**Report to General Manager**Attachments:  
Nil**SUBJECT:** Pattons Slipway - 62 Willoughby Street, Kirribilli - DA 313/19**AUTHOR:** Geoff Mossemeneer, Executive Planner**ENDORSED BY:** Joseph Hill, Director City Strategy**EXECUTIVE SUMMARY:**

This Development Application is seeking consent to carry out alterations and additions to an existing boat repair facility and marina including the removal of slip rails, timber jetties and mooring piles and construction of a boatshed, installation of a boat crane with the capacity for 35T vessels, installation of a floating pontoon to accommodate five (5) vessels, new concrete hardstand, vehicular crossing and ancillary works.

FIGURE 1

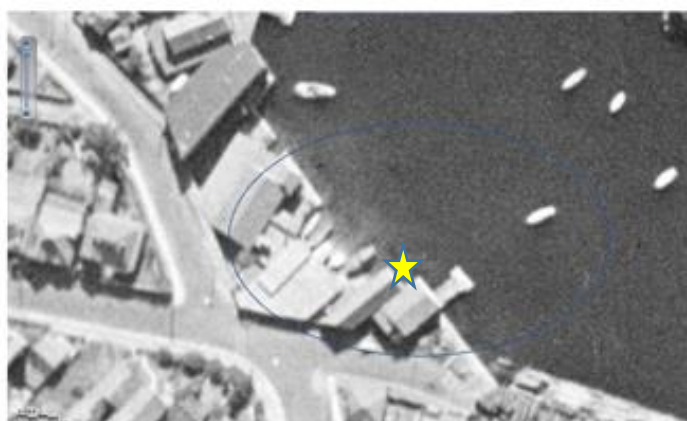
*An analysis of the marina area comparing historical images (FIGURE 1), highlights changes that have modified the form of the existing marine structures over time within the marina area. The images indicate that the low scale character within the marina is retained. The historical images of the earlier boatshed relating to the subject proposal, shows a two storey form facing the harbour and the street facing scale to be single storey. At that time, the single storey Willoughby Street elevation appears to be set back and below the street and its scale to the street appears to be smaller than the street facing elevation of the 1980s which appears to be built to the street alignment suggesting that the earlier building underwent some changes. The form of the adjacent building has also changed - the Council owned building has been rebuilt as a low scale concrete structure with a viewing platform above.*

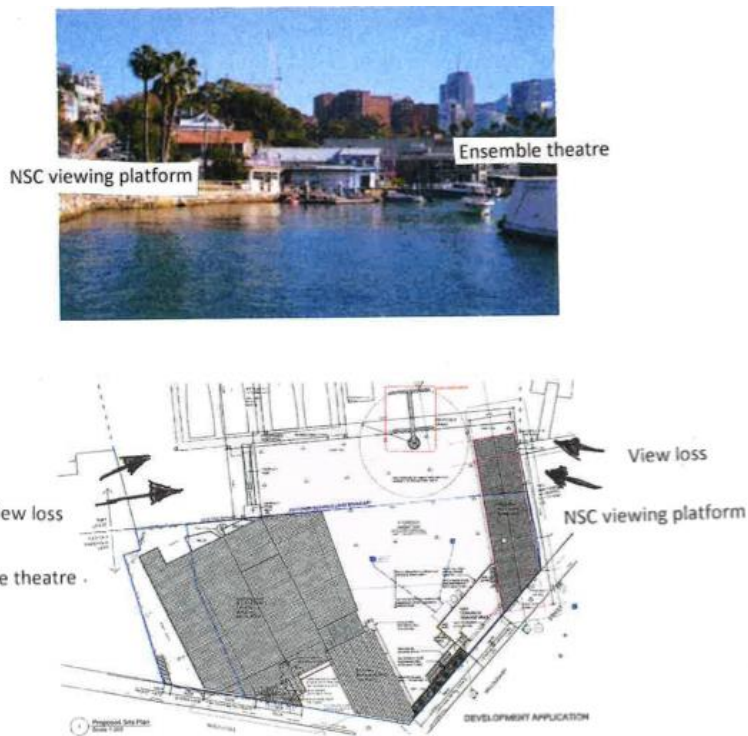
The boatshed is proposed as restoration of the existing boatshed. The previous boatshed was destroyed by fire nearly 30 years ago. The use of boat repairs on the site is permissible and “Existing Use” rights are not relevant to the application. There is no right to rebuild and there are no details to show that the proposed boatshed is a restoration. The boatshed was not a heritage item.

The lower level of the boatshed is proposed as store with the upper level with balcony as office. There is no internal link between the floors. The office is accessed from the street. The application is silent on the proposed use. It would appear to be a potential area to lease as the slipway already has offices on site.

The upper floor and pitched roof are out of character with nearby buildings. The boatshed’s height and scale are a concern.
